City of West Linn
PRE-APPLICATION CONFERENCE MEETING
SUMMARY NOTES
December 1, 2011

SUBJECT: Class I Design Review for changes to exterior wall of commercial space at Willamette Village shopping center, 19064 Willamette Drive

View of space to be occupied by bank. Part of set of windows on the right is proposed for ATM, drop box, surrounding wall area

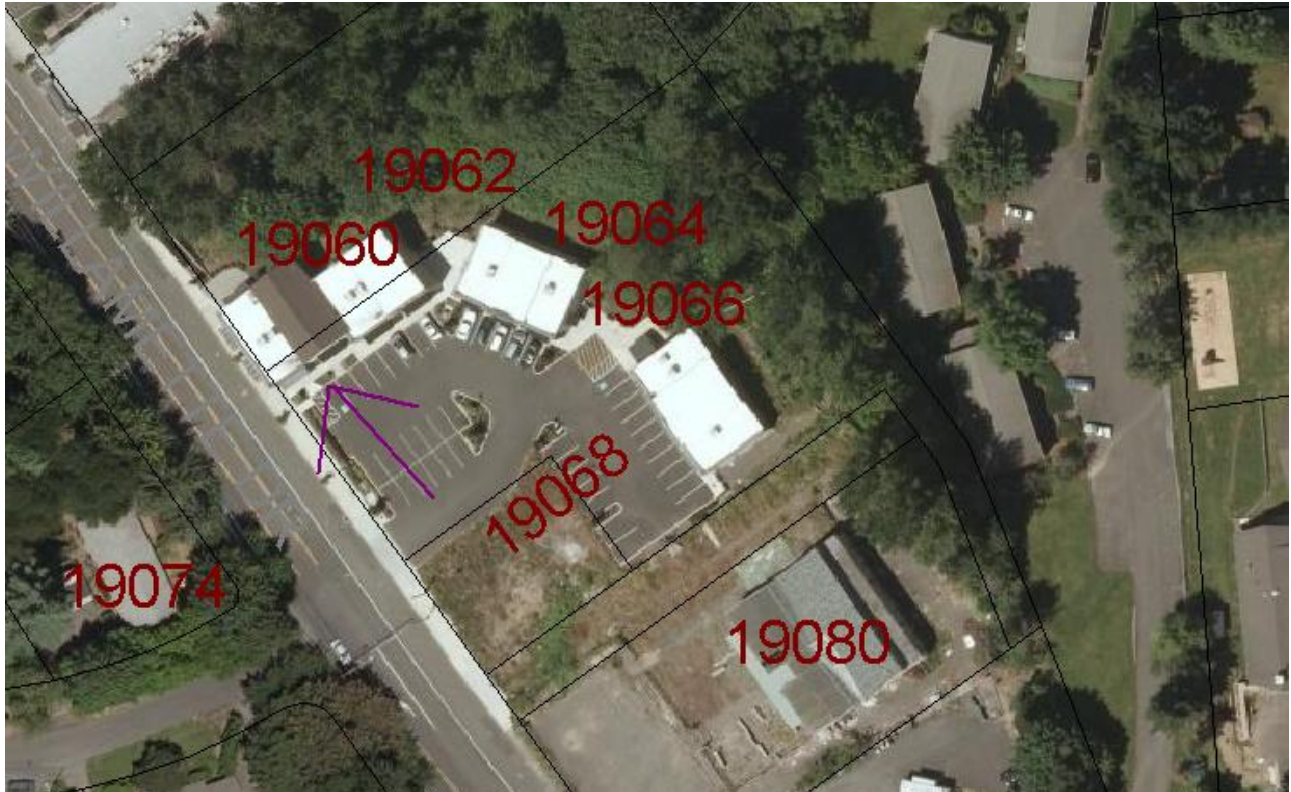
Since design review is already to be required due to the changes related to the wall, the design review criteria for crime prevention, safety, and defensible space should also be reviewed under the proposal due to the proposed ATM and drop box (including for any lighting that may be installed to aid in the use and safety of these features).

Some of the main issues in this design review would be matching existing architecture, and ensuring that transparency requirements continue to be met. Transparency is the amount of wall space featuring windows of at least 3 feet in height. There is approximately 50% transparency along the Willamette Drive side of the building and just over 60% transparency on the parking lot side of the building. The latter is the case whether the bank and 1st Choice Market spaces are counted separately or together as one building. They are one continuous frontage but were applied for as two buildings during the design review for Willamette Village (file DR-06-43) and should be able to stand alone in terms of transparency. 55.100(B)(6)(f) requires 60% transparency on the front of a building and 30% or more on a side visible from a major street. For DR-06-43 the side facing the parking lot was apparently considered the front and the side facing Willamette Drive was considered a side.

The photo caption next to 55.100(B)(6)(f) in the CDC says windows can be transferred between sides so transparency requirements can be met. This would be necessary here as the proposal would take the front transparency below 60%. If transparency is counted via transferral as discussed above, subtracting the width of the proposed wall panel and ATM from the amount of transparency along the street side would reduce this side's transparency to approximately 30% transparency. This would be the minimum amount for a side of a building facing an arterial street such as Willamette Drive. The applicant will have to be sure that a small enough portion of the building is converted from window to wall/ATM/box in order to continue to meet transparency requirements one way or another.
